Addendum #1

Addendum No.: One (#PG)	Date Addendum Issued: Feb. 17, 2023
Issuing Office/Point of Contact: Copper River Watershed Project Kate Morse, Program Director P.O. Box 1560 511 First St. Cordova, AK 99574 (907)424-3334 kate@copperriver.org	Previous Addenda Issued: none
Project: Copper River Watershed Habitat Enhancement Project, Cordova EVOS Sites COP 1 and 33 (Fish Passage Improvement at Sheridan River Tributary and Black Hole Creek), Copper River Highway	Due date for bids: February 27, 2023 5pm AKST

Title: Copper River Watershed Habitat Enhancement Project, Cordova EVOS Sites COP 1 and 33 (Fish Passage Improvements at Sheridan River Tributary and Black Hole Creek)

CORDOVA FISH PASSAGE IMPROVEMENTS
BLACK HOLE CREEK - COP 33
STREAM DIVERSION & TRAFFIC
CONTROL PLAN
CORDOVA, ALASKA

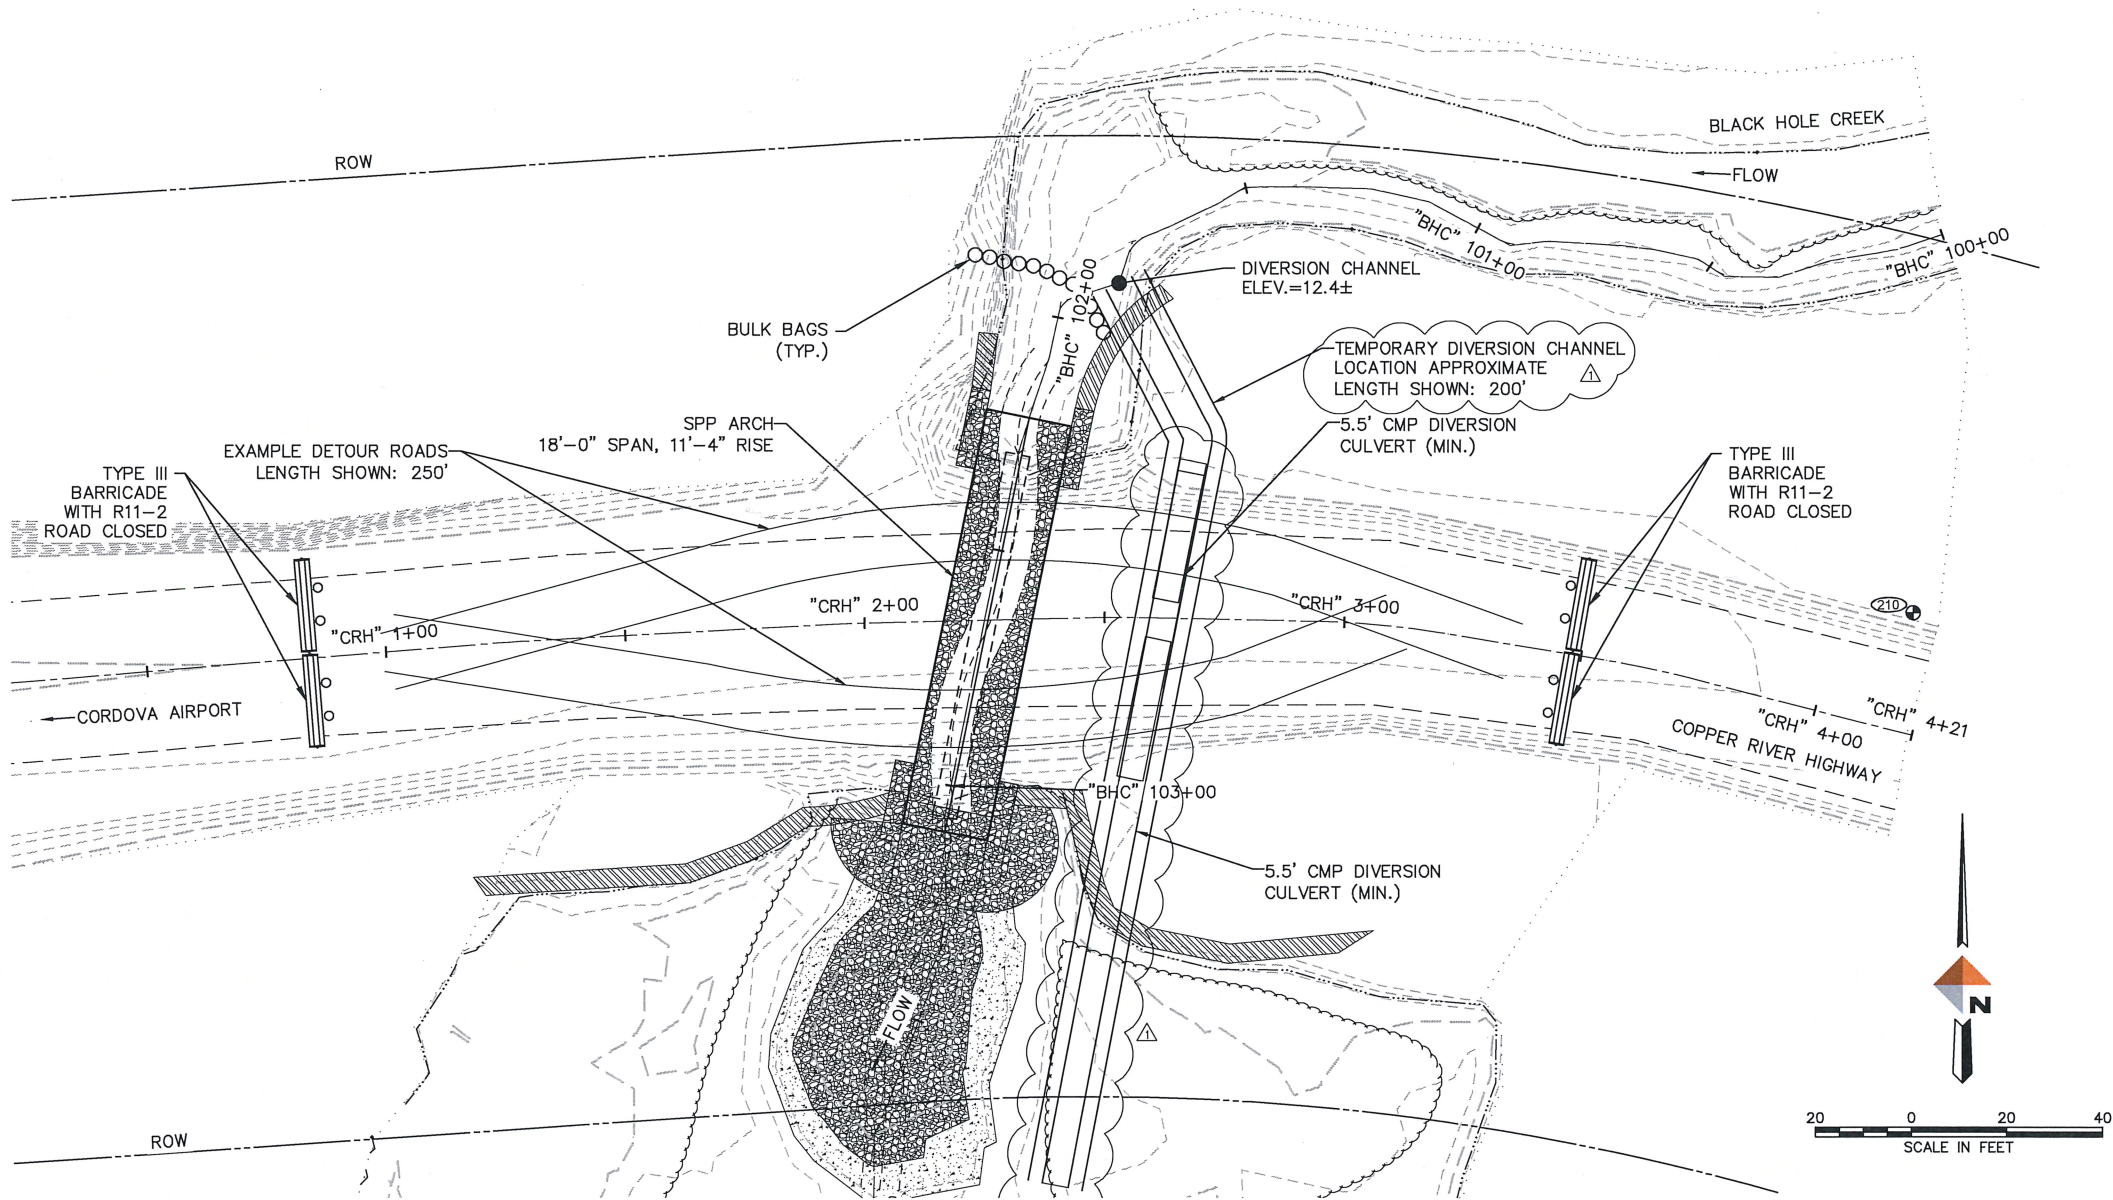
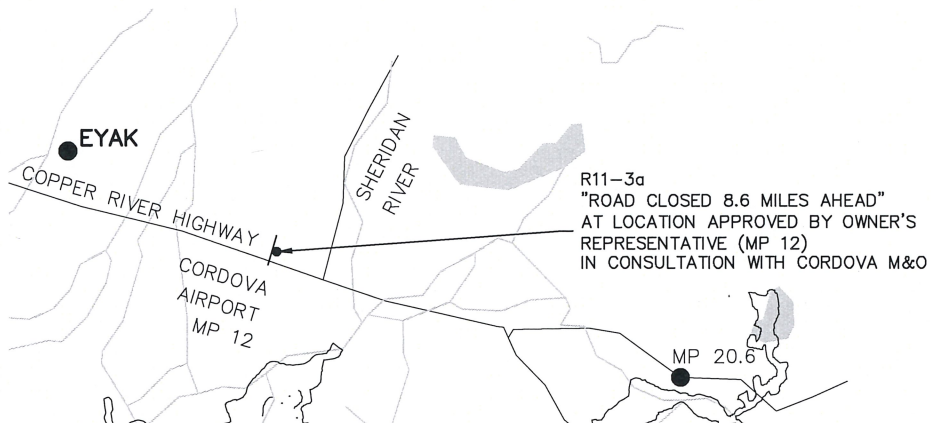
REVISIONS			
REV	DATE	DESCRIPTION	BY
1	2/19/23	DIVERSION LENGTH UPDATE
